SB-10045303-5547

Title: Air Horn Broken Off

Applies To: LoneStar model built with a single Air Horn Feature Code 0008WCL between May 11, 2011 through July 12, 2012

Wrong Bracket Installation

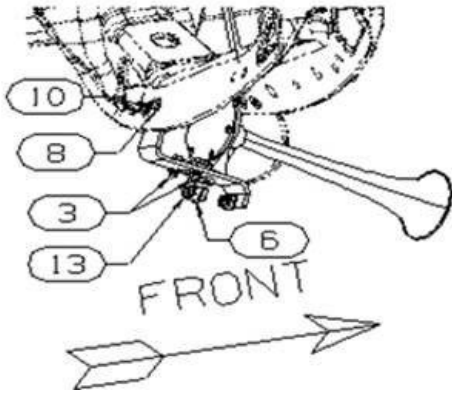
A limited number of LoneStar units have been identified to have been built with the mounting bracket mounted on the wrong side of the crossmember and air horn may be mounted on the lower side of the mounting bracket. This could allow the horn to contact the front axle during normal operation of the vehicle generally resulting in extensive damage to the air horn assembly

1. Inspect mounting bracket to verify that bracket is mounted to the inside of the crossmember as pictured
2. Inspect Air Horn Mounting to be sure horn is mounted on top of the bracket.

Install bracket so that it is mounted to the inside of the crossmember and horn assembly is mounted on top of the bracket
